TECHNICAL EVALUATION REPORT  
INDIAN POINT UNIT 2  
STATION BLACKOUT EVALUATION

TAC No. 68556

Final  
November 21, 1990

FIGURE 1. INDIAN POINT 2 ALTERNATE AC POWER SYSTEM

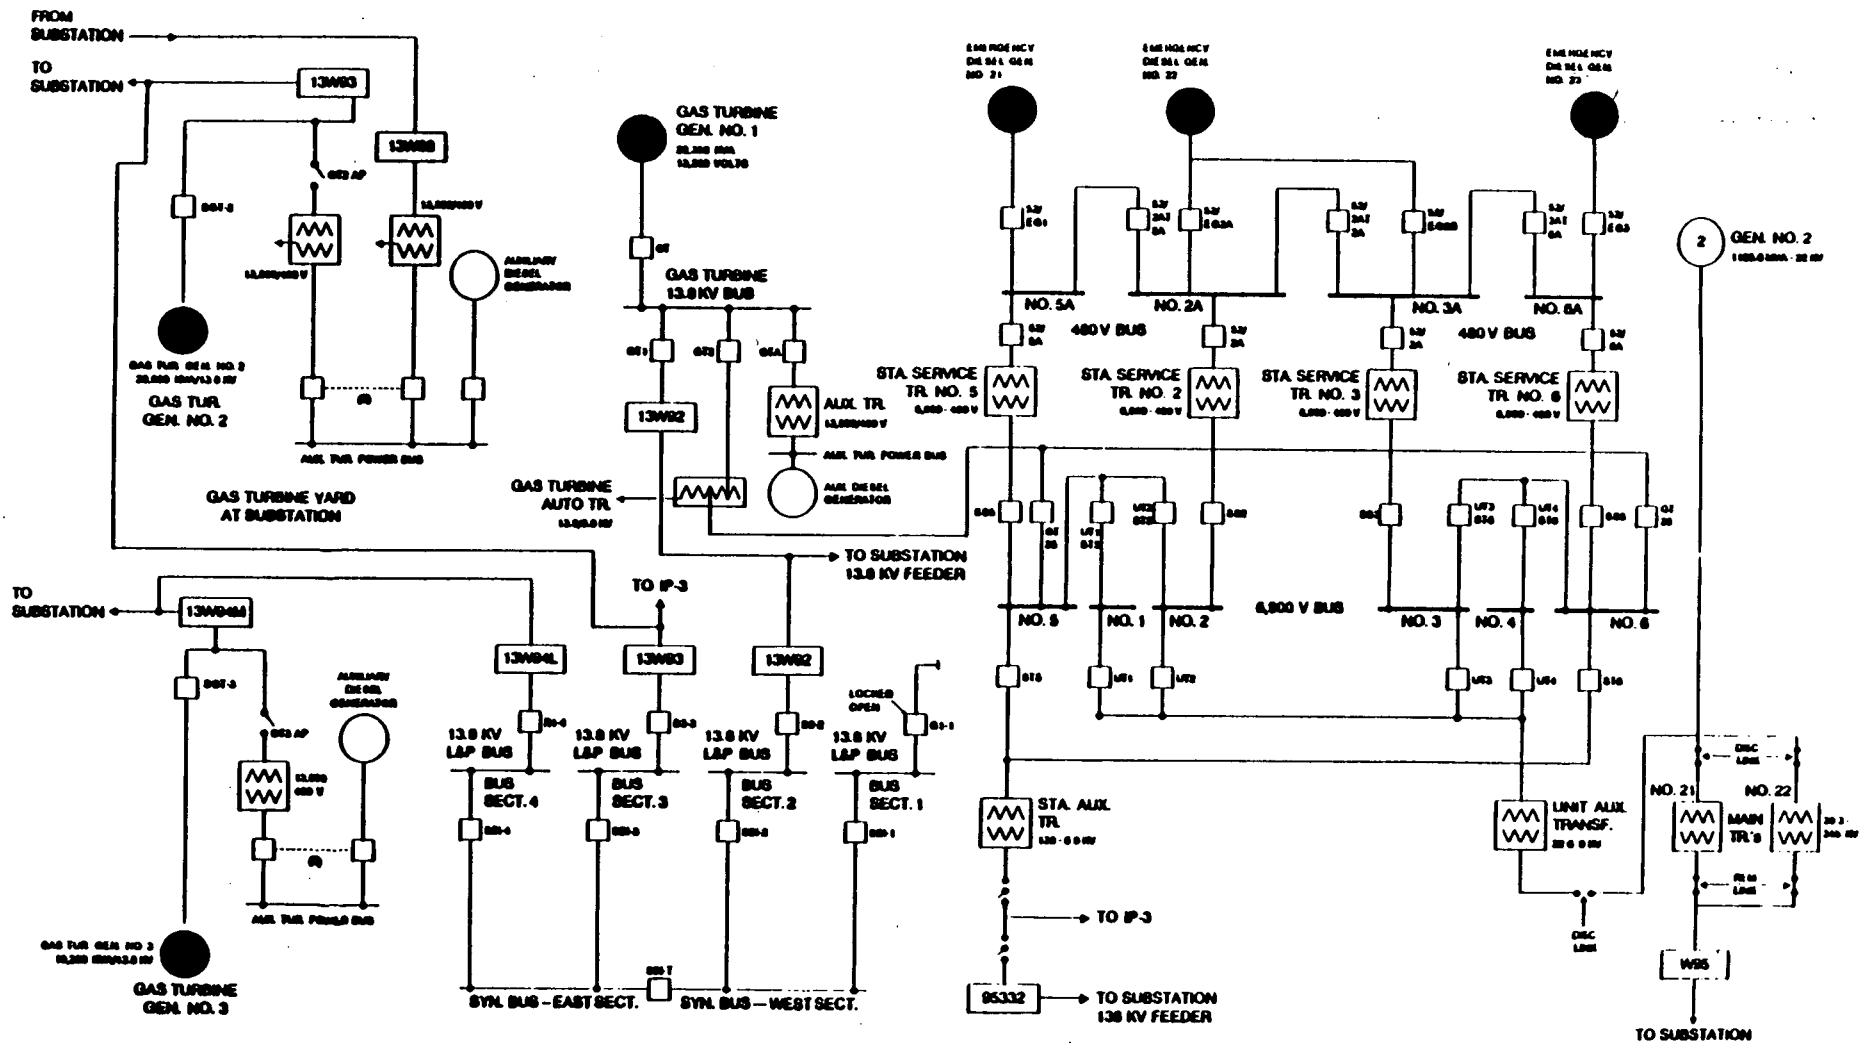
One of the AAC power sources (GT-1) is located on the Indian Point Unit 1 (IP-1) property, which is directly adjacent to the IP-2, the other two sources (GT-2 and GT-3) are located at the Buchanan substation, which is located about half a mile from IP-2. GT-2 and GT-3 feed power through three underground (13.8 kV) feeders to IP-1 switchgear. IP-2 can receive power from IP-1 switchgear, and any of the three gas turbines via an underground 13.8 kV feeder line.

The licensee stated that GT-1 and GT-3 have blackstart capabilities and that GT-2 currently has limited blackstart capability. A blackstart diesel generator will be installed to give GT-2 a complete remote blackstart capability from the IP-2 control room.

Based on the telephone conversation on June 4, 1990, and the information available in the plant's UFSAR, we conclude that following the completion of the above modification and tests, the licensee's AAC system will meet the criteria given in the guidance of NUMARC 87-00, Appendix B.
